**Economic and Social Council**Distr.: General
22 July 2024

World Forum for Harmonization of Vehicle Regulations**Working Party on General Safety Provisions****128th session**

UN Regulation No. 39 (Speedometer and Odometer)**Proposal for the 02 Series of Amendments to UN Regulation No. 39 (Uniform Provisions concerning the Approval of Vehicles with regard to the Speedometer and Odometer Equipment Including its Installation)****Submitted by the Task Force on UN Regulation No. 39 covering mileage values ***

Model A

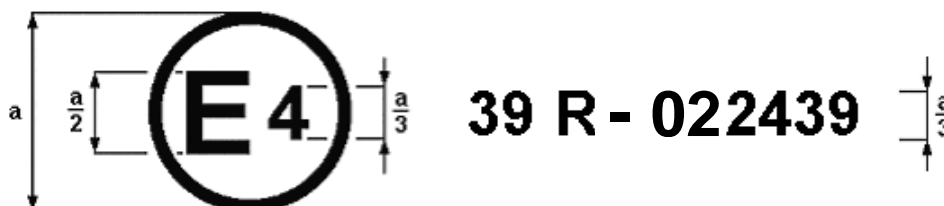
The above approval mark affixed to a vehicle shows that the vehicle type concerned has been approved in the Netherlands (E 4), pursuant to Regulation No. 39. The approval number indicates that the approval was granted in accordance with the requirements of UN Regulation No. 39 incorporating the ~~01~~02 series of amendments.

Model B

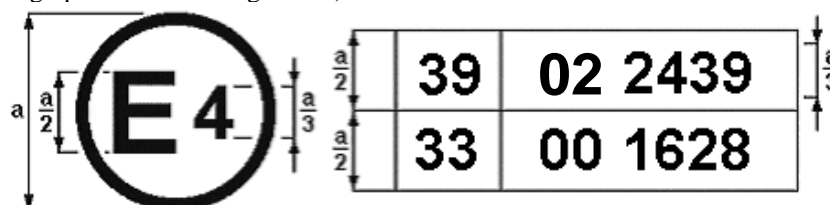
The above approval mark affixed to a vehicle shows that the vehicle type concerned has been approved in the Netherlands (E 4) pursuant to Regulations Nos. 39 and 33.¹ The approval numbers indicate that, at the dates when the respective approvals were granted, UN Regulation No. 39 incorporated the ~~01~~02 series of amendments and Regulation No. 33 was still in its original form.
